**Subject: Site Plan Control Application Comment Response - FINAL  
OZ-1 BESS Project, 157 7th Street SW, Chesley, ON  
PRI Project No.: 25-253**

As requested, PRI Engineering Corp. (PRI) has reviewed the comments from The Corporation of the Municipality of Arran-Elderslie dated July 29, 2025 prepared by the Chief Administrative Officer Emily Dance, the following are our responses to the provided comments.

TRUCK TURNING PLAN  
1:1350

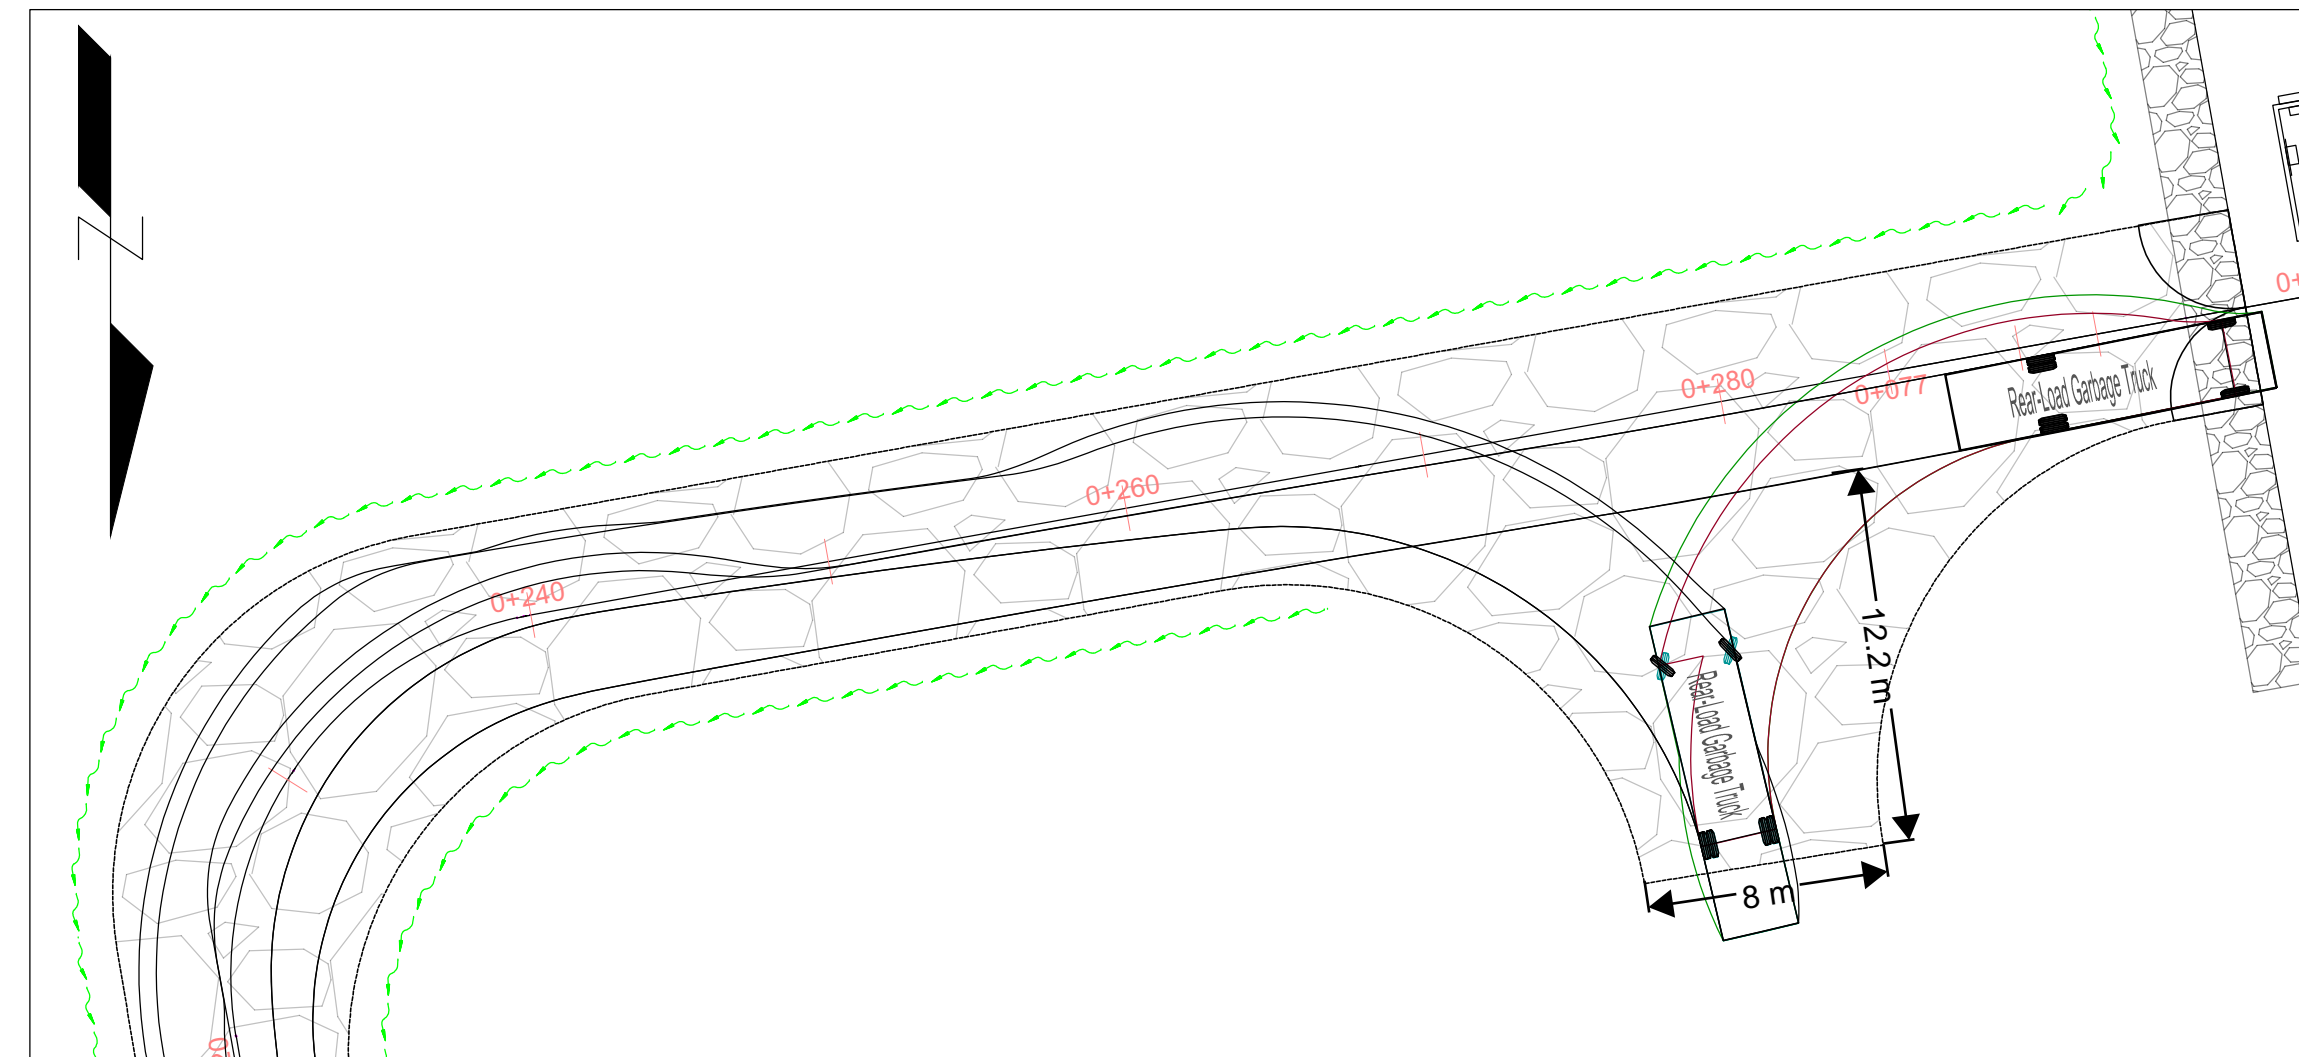
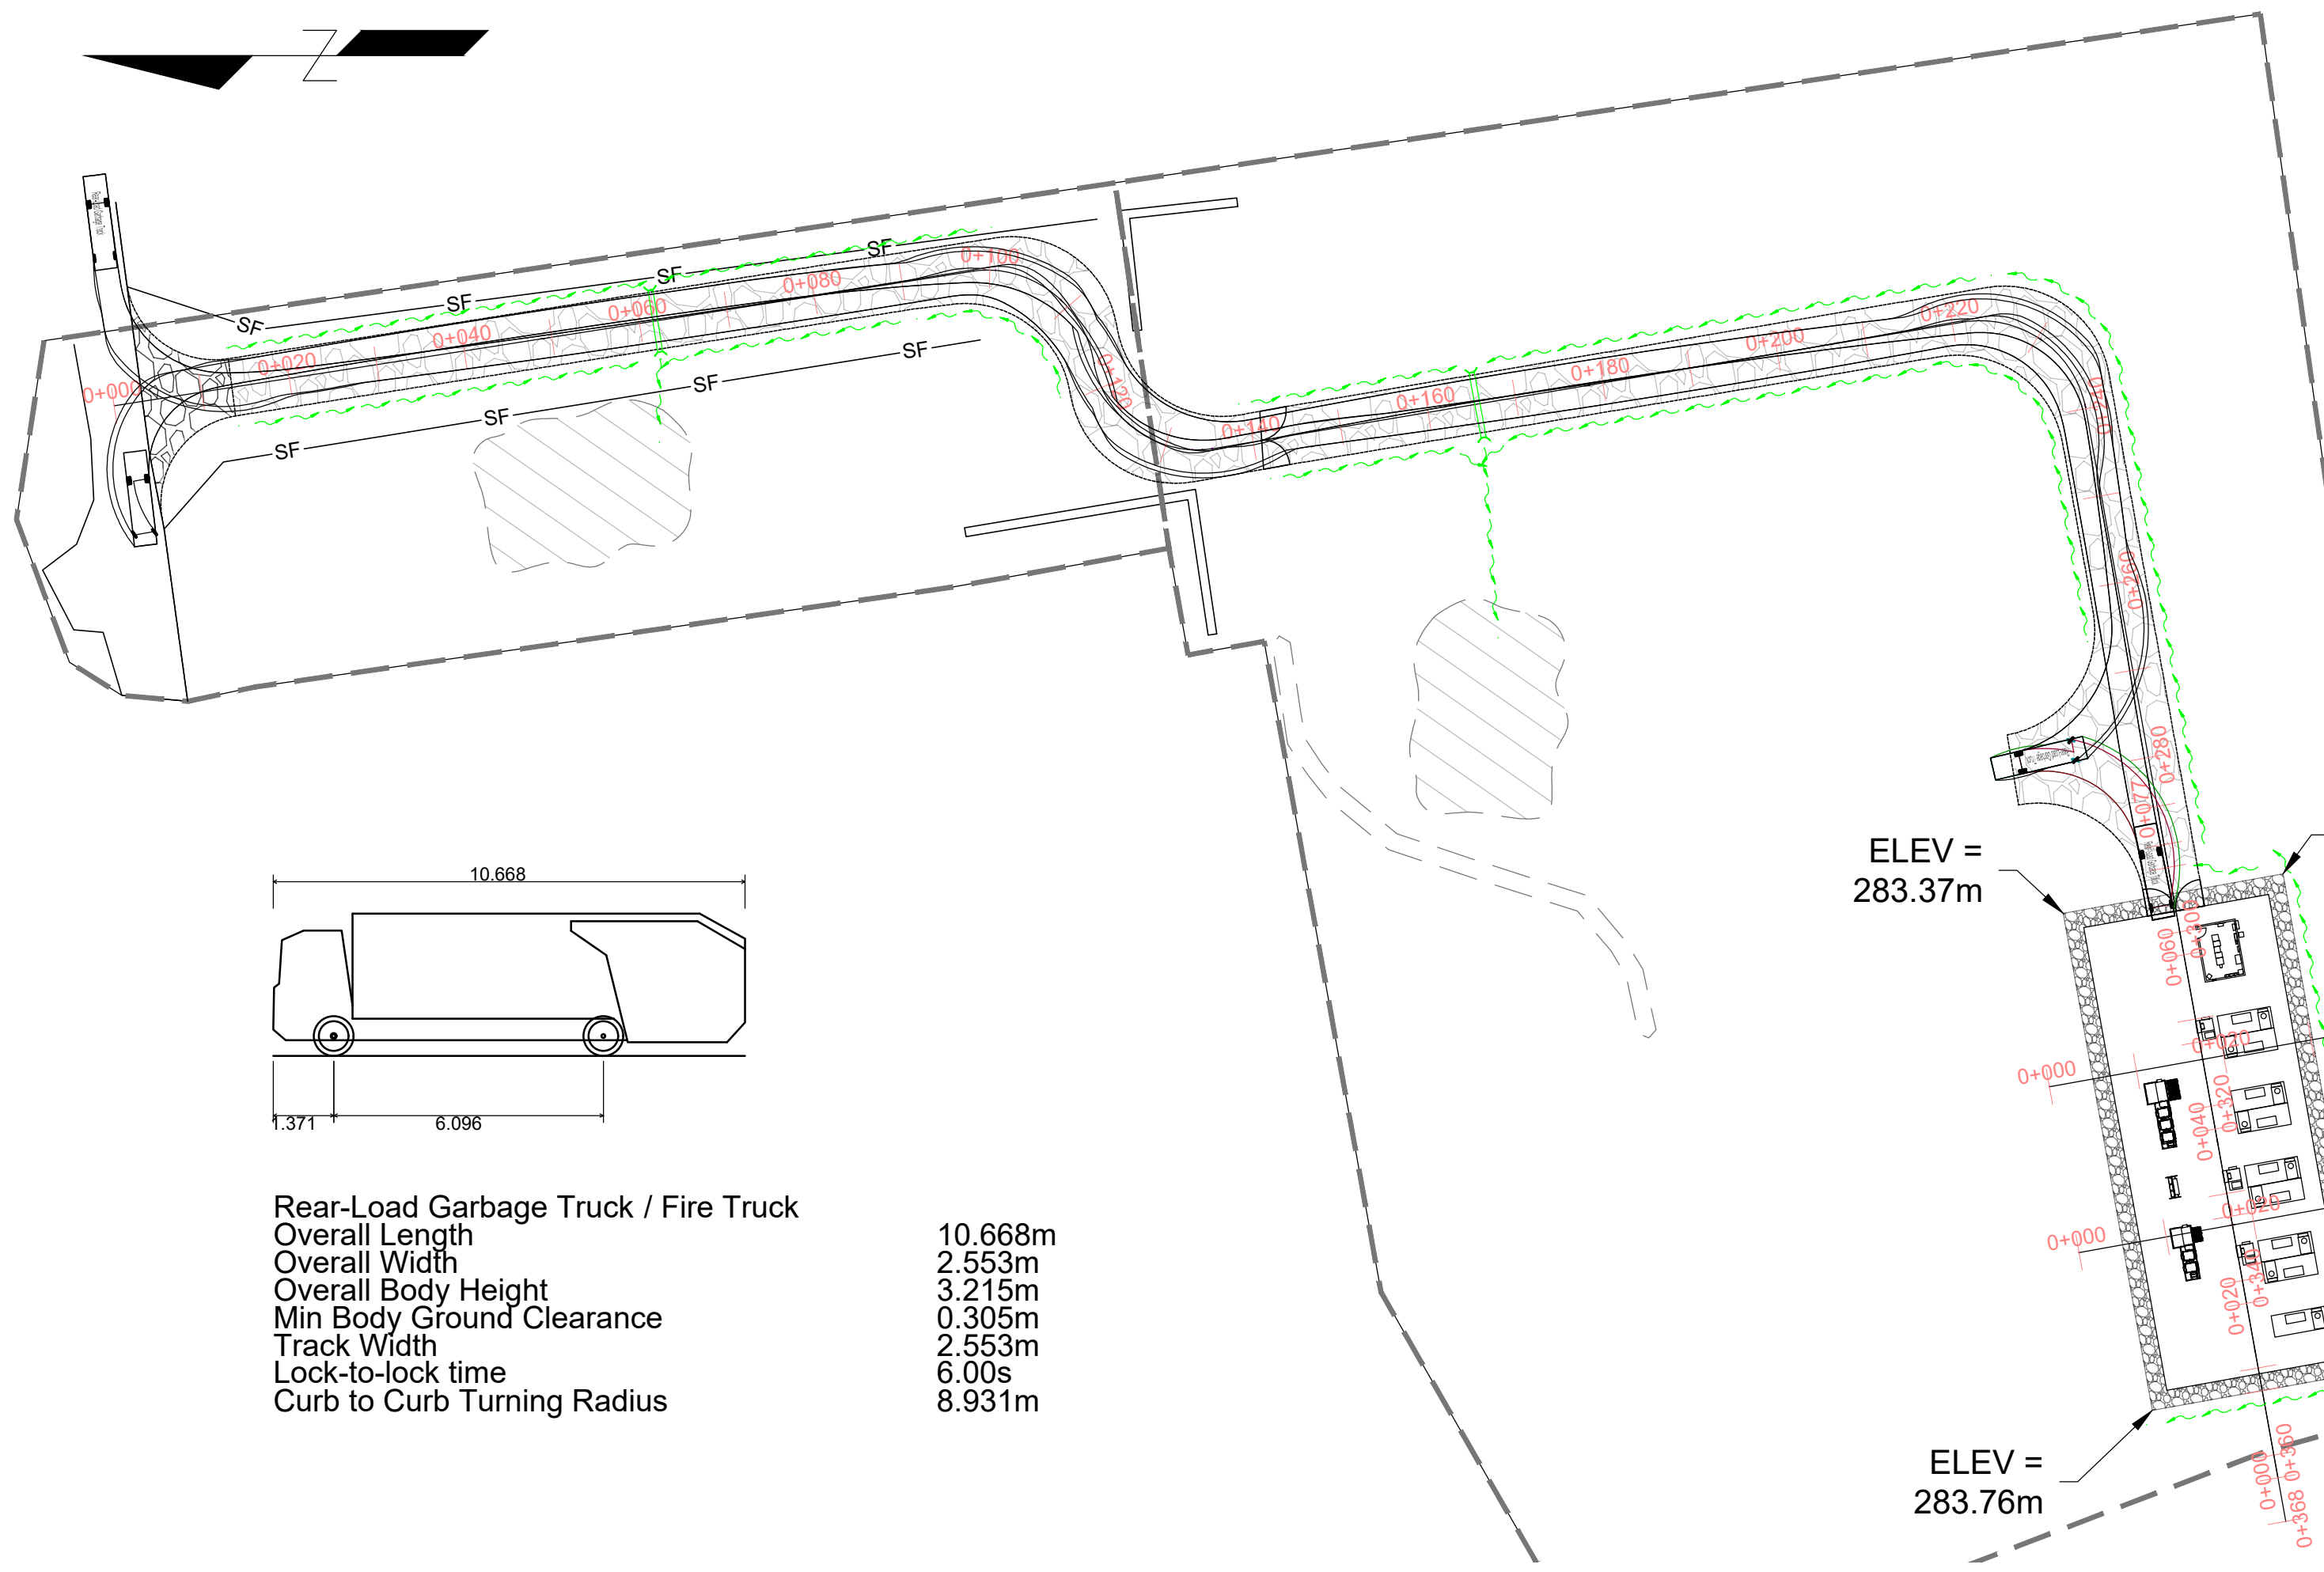
- 2) Hammerhead: We confirm that the hammerhead can accommodate larger trucks such as fire trucks and garbage trucks. It should be noted that the municipalities fire truck fleet, consists of freightliner M2 102 chassis, which are used for the pumper, tanker and rescue units. This freightliner unit has a 9.8 m bumper to bumper dimension with 2 axels. A garbage truck was used for modeling purposes as this chassis is slightly larger than the freightliner chassis used for fire trucks. As such we have determined a 12 m hammerhead will be sufficient to accomplish this. A truck turning movement plan has been added as Drawing C03 attached.

ROAD CL PROFILE  
1:1250

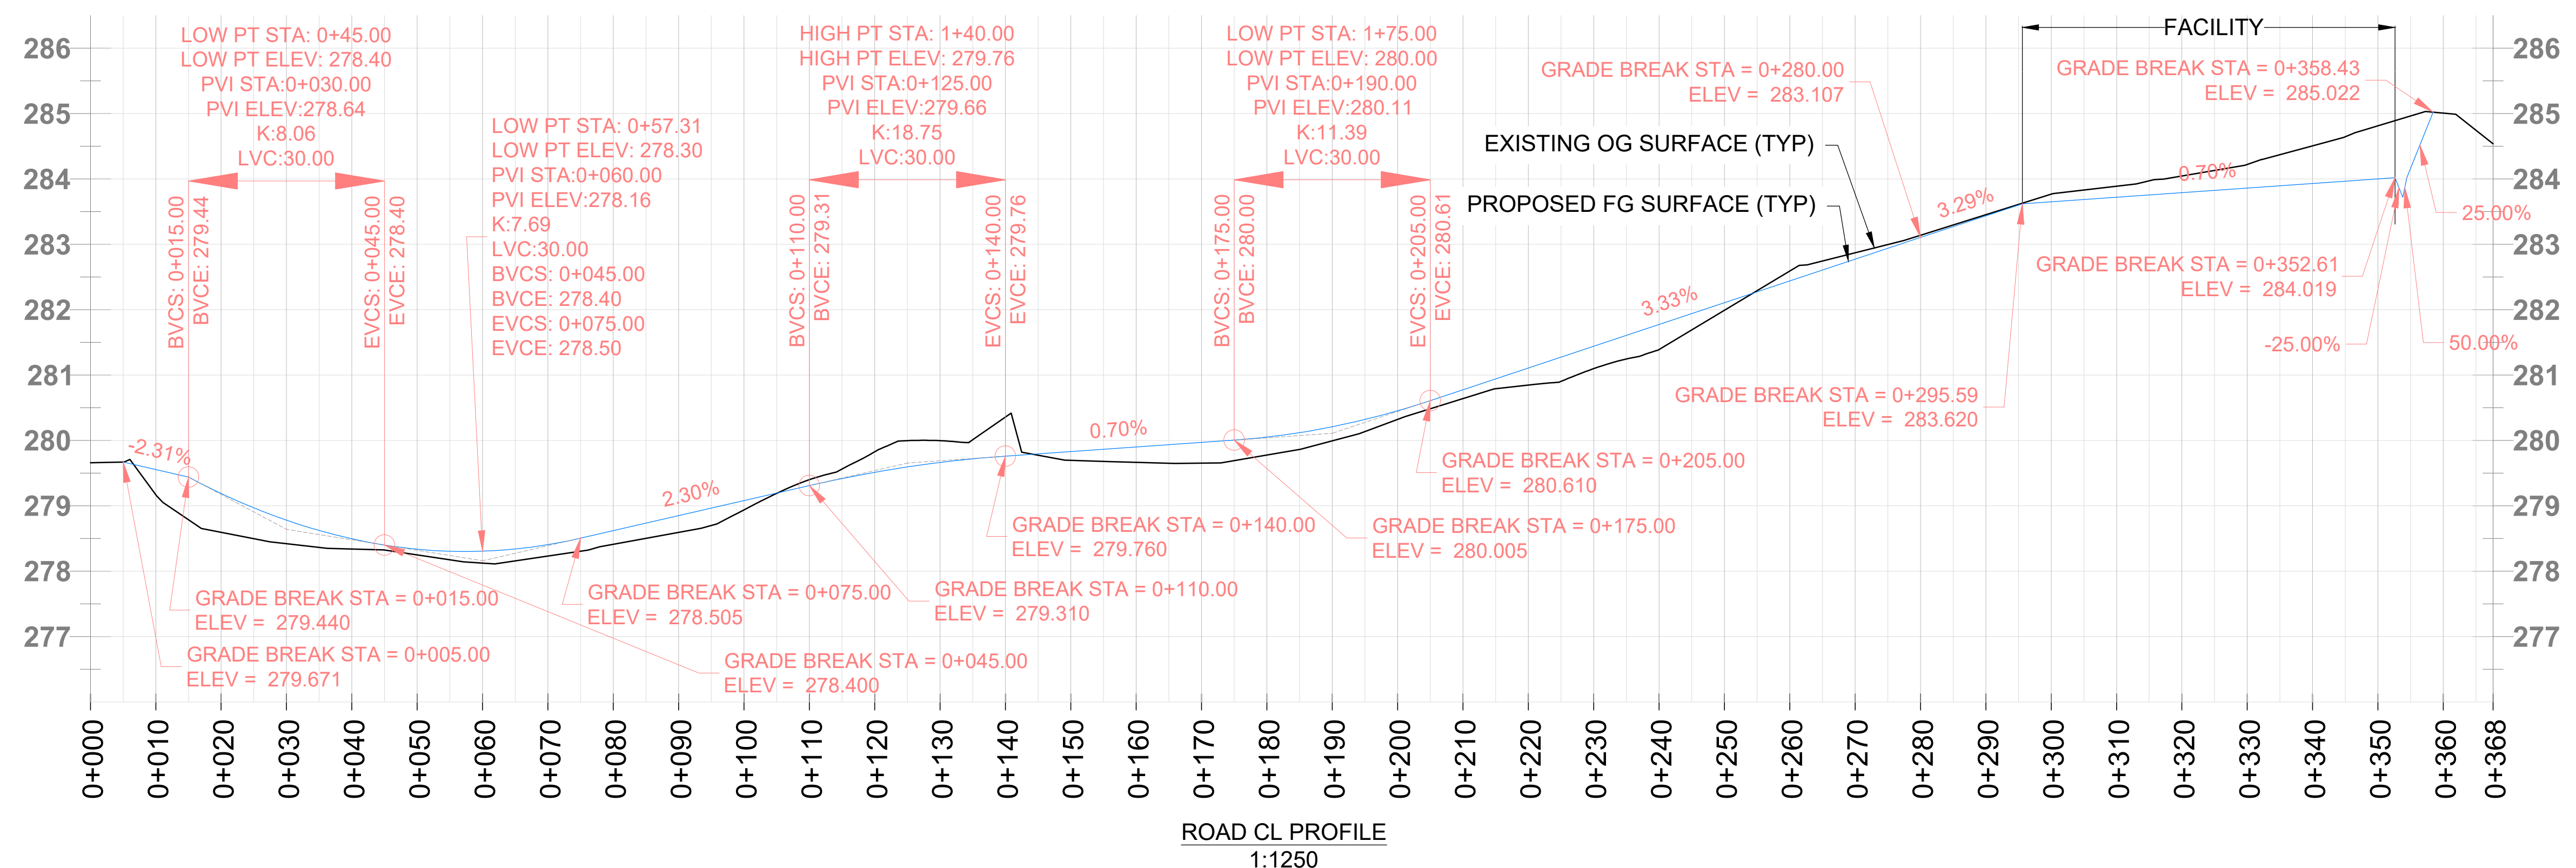
- 3) Road Profile: We have added stations and road elevations at critical points, vertical curves, K values etc. to the profile.
- 4) Because the road will be built up at the low point, excess runoff from Catchment area 1 can pool there which is what is currently occurring, based on existing grades. In addition, we propose to install a small, grassed berm at the low point to the north of the facility site to trap excess runoff from Catchment area 2. These design elements have been proposed to allow for the reflection of existing conditions post-construction as it relates to where the water will pond or discharge to.
